D23/99426

**TILLEY RECREATION PARK CLUBROOM CONSTRUCTION -
TENDER RECOMMENDATION**

- 1. Tilley Recreation Park Clubroom Design
- 2. Mark up of scope reduction - Tilley Recreation Park Clubroom

TILLEY RECREATION PARK CLUBROOM
CITY OF TEA TREE GULLY
HANCOCK RD & YATALA VALE RD, FAIRVIEW PARK SA 5126
GROUND FLOOR PLAN

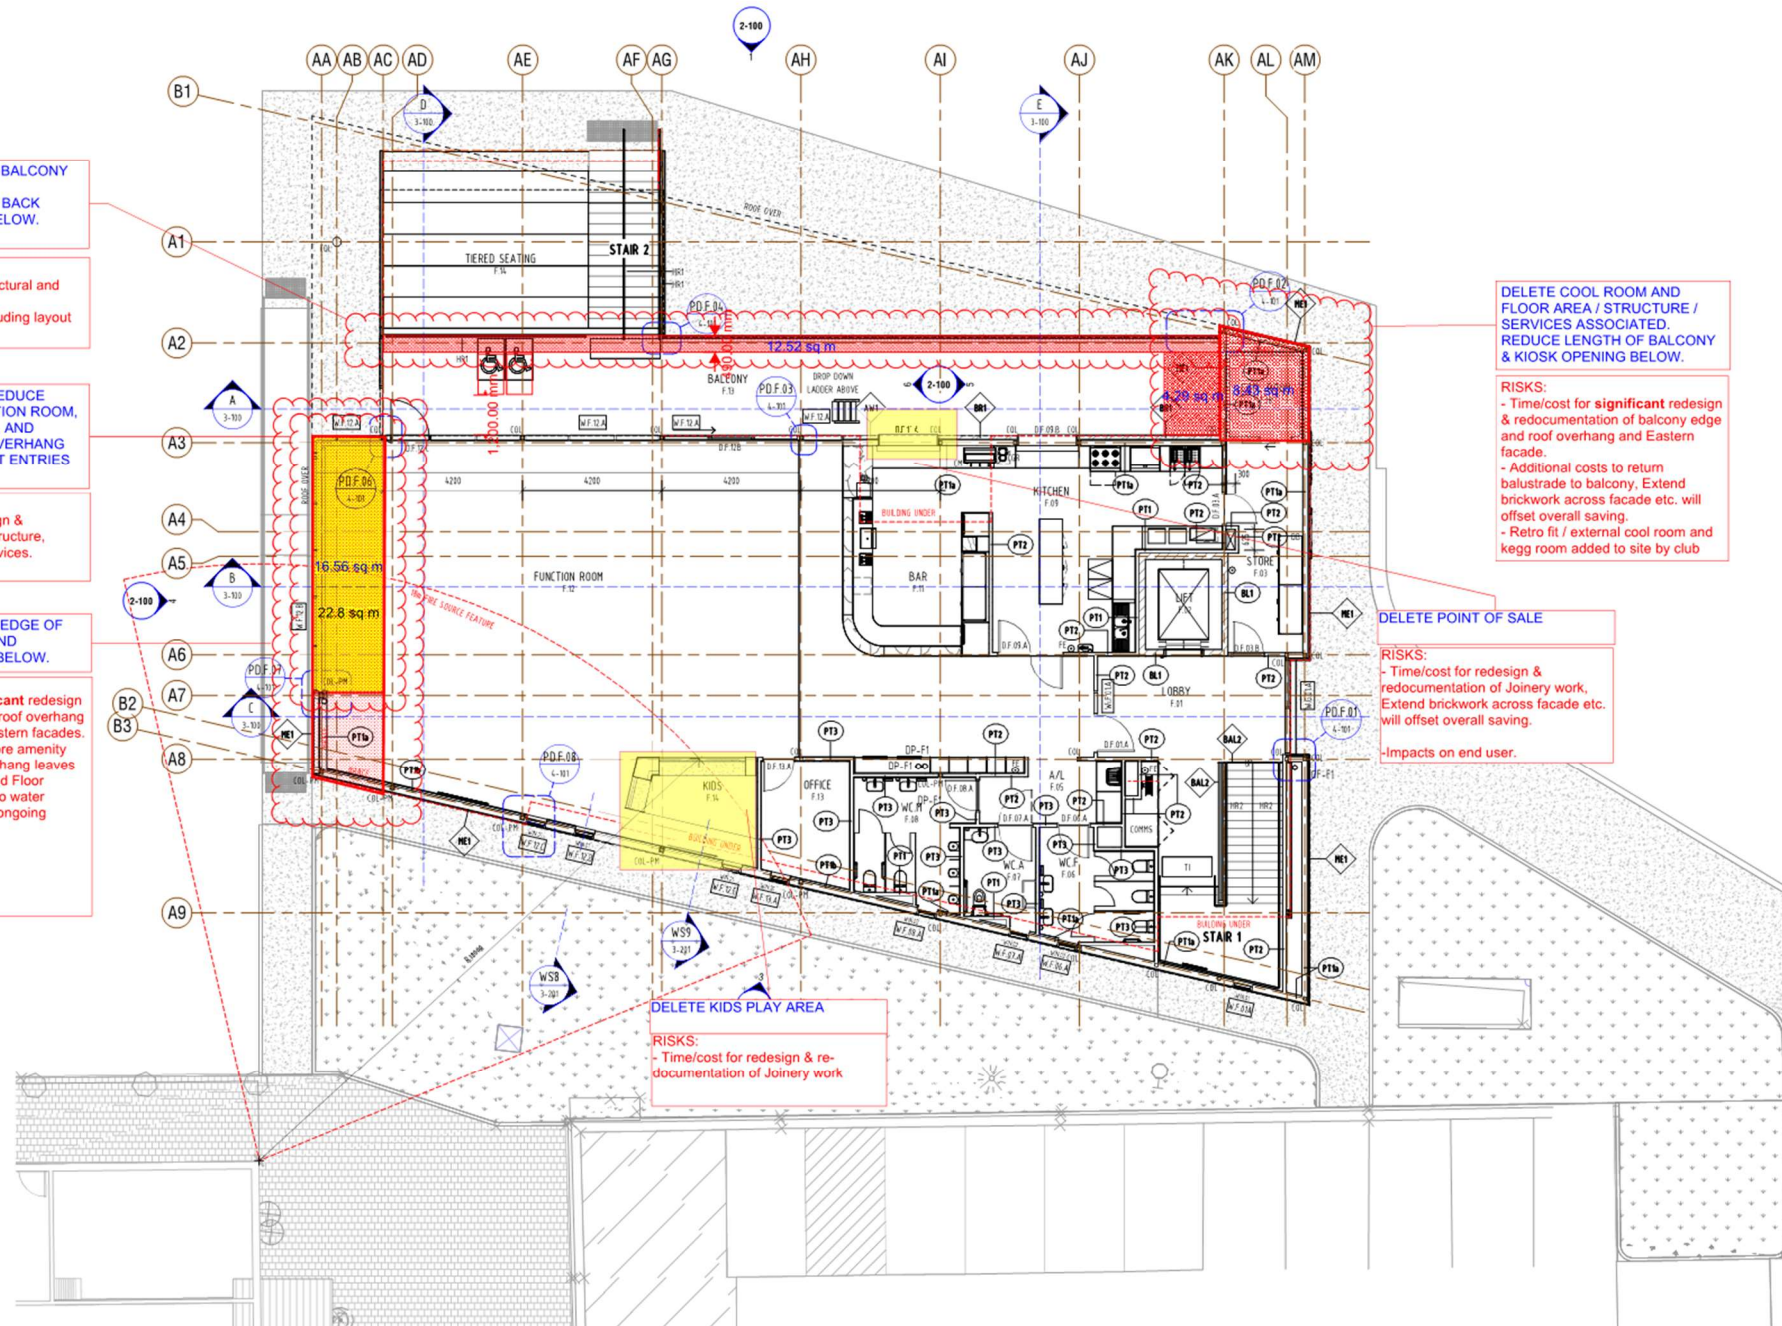
REDUCE WIDTH OF BALCONY ABOVE AND BRING STRUCTURAL GRID BACK 490mm TO ALIGN BELOW.

RISKS:
- Time/cost for architectural and structural redesign & redocumentation, including layout of umpires.

OPTION TO ONLY REDUCE PORTION OF FUNCTION ROOM, SHOWN IN YELLOW, AND CONTINUE ROOF OVERHANG ABOVE TO PROTECT ENTRIES BELOW.

RISKS:
- Time/cost for redesign & redocumentation of structure, ceiling layout, inc. services.

DELETE CORNER & EDGE OF FUNCTION ROOM AND CLEANERS STORE BELOW.

RISKS:
- Time/cost for significant redesign & redocumentation of roof overhang and Southern and Western facades.
- Removes cleaner store amenity
- Removal of roof overhang leaves no protection to Ground Floor external doors - risks to water proofing of building & ongoing maintenance issues.

DELETE COOL ROOM AND FLOOR AREA / STRUCTURE / SERVICES ASSOCIATED. REDUCE LENGTH OF BALCONY & KIOSK OPENING BELOW.

RISKS:
- Time/cost for significant redesign & redocumentation of balcony edge and roof overhang and Eastern facade.
- Additional costs to return balustrade to balcony. Extend brickwork across facade etc. will offset overall saving.
- Retro fit / external cool room and kegg room added to site by club

DELETE POINT OF SALE

RISKS:
- Time/cost for redesign & redocumentation of Joinery work. Extend brickwork across facade etc. will offset overall saving.

DELETE KIDS PLAY AREA

1 GROUND FLOOR PLAN
1:100

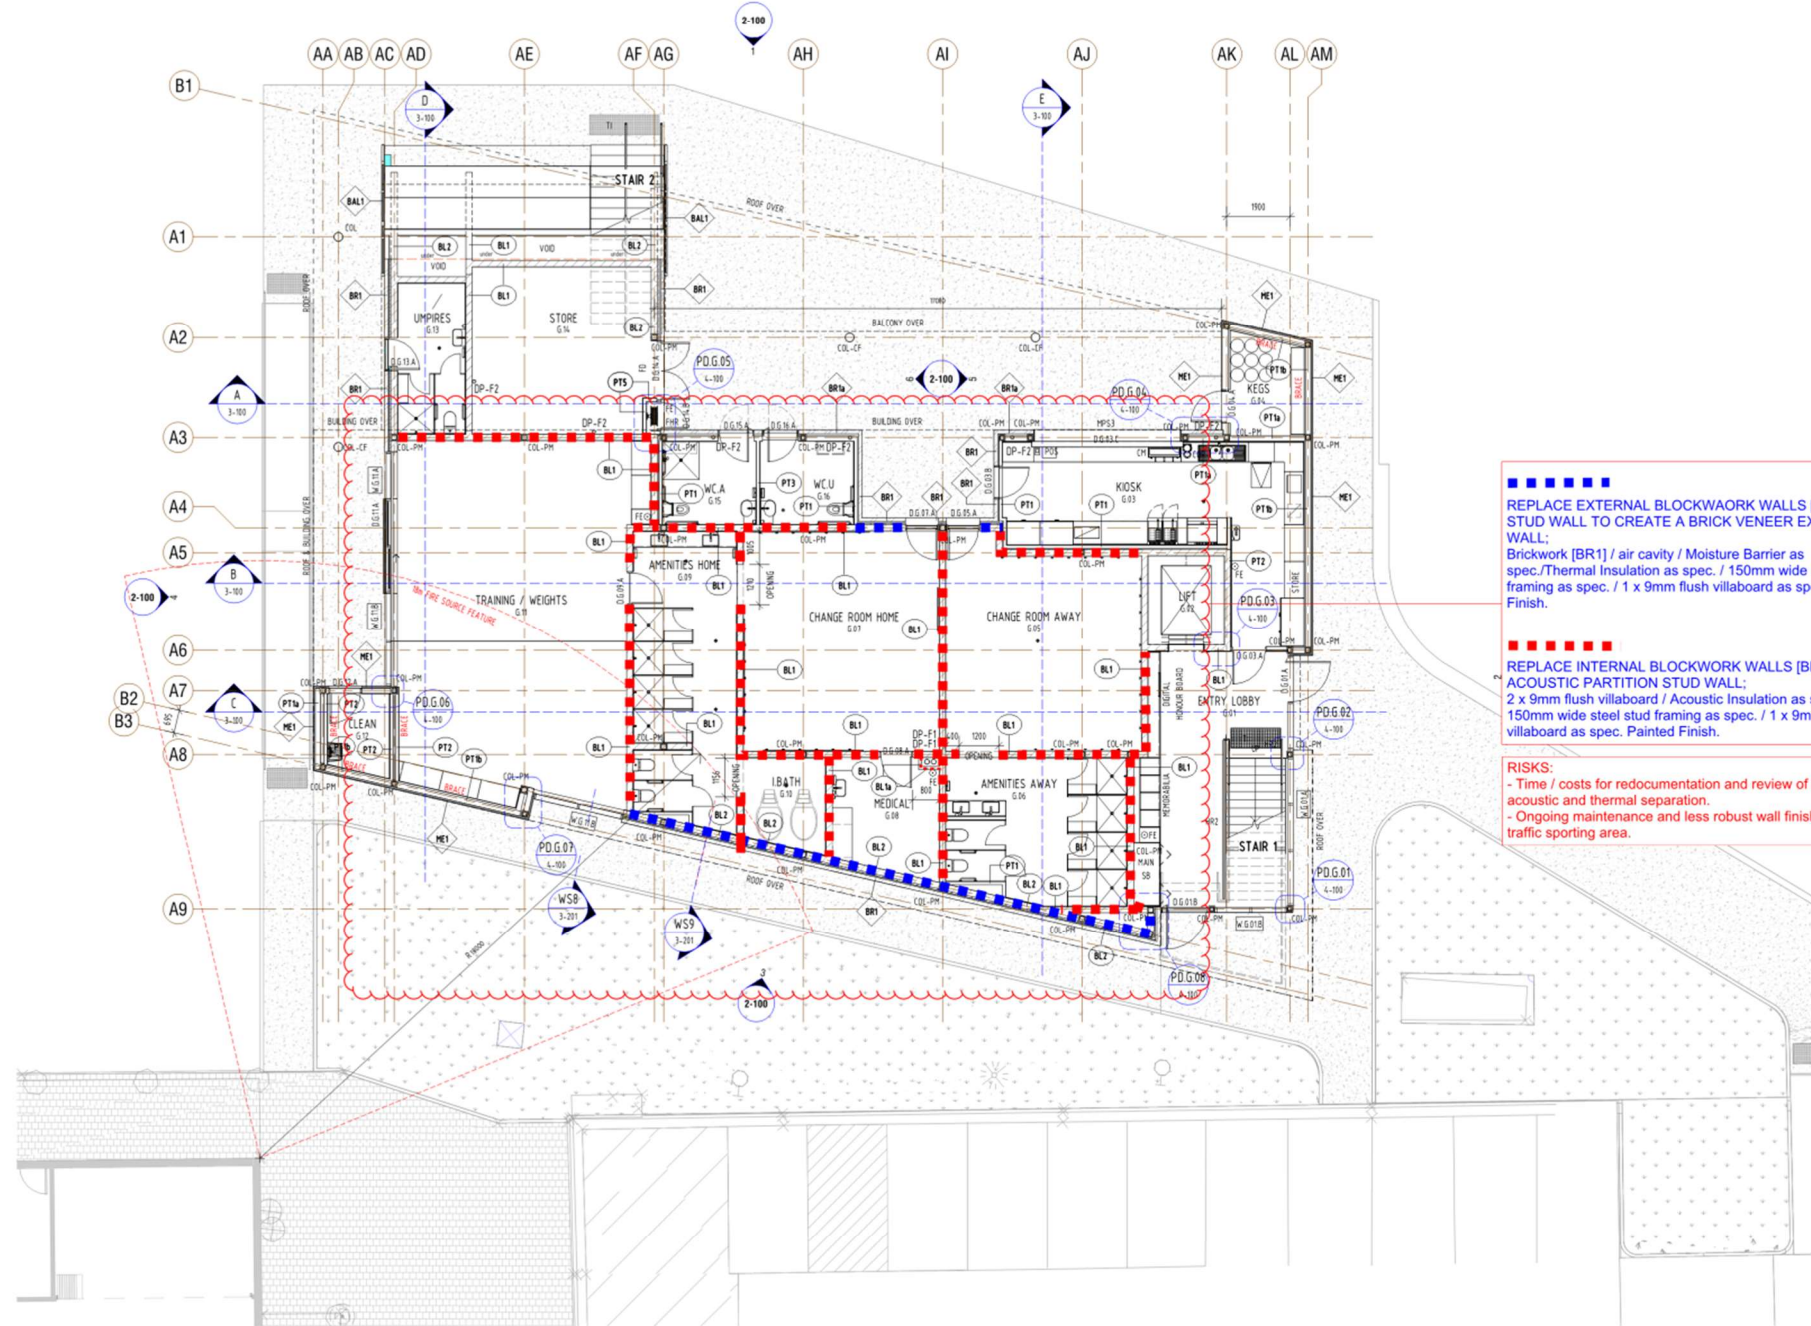
CHANGE TO BLOCKWORK WALLS MARKUP.

REPLACE EXTERNAL BLOCKWORK WALLS [BL2] WITH STUD WALL TO CREATE A BRICK VENEER EXTERNAL WALL:
Brickwork [BR1] / air cavity / Moisture Barrier as spec. / Thermal Insulation as spec. / 150mm wide steel stud framing as spec. / 1 x 9mm flush villaboard as spec. Painted Finish.

REPLACE INTERNAL BLOCKWORK WALLS [BL1] WITH ACOUSTIC PARTITION STUD WALL:
2 x 9mm flush villaboard / Acoustic Insulation as spec. / 150mm wide steel stud framing as spec. / 1 x 9mm flush villaboard as spec. Painted Finish.
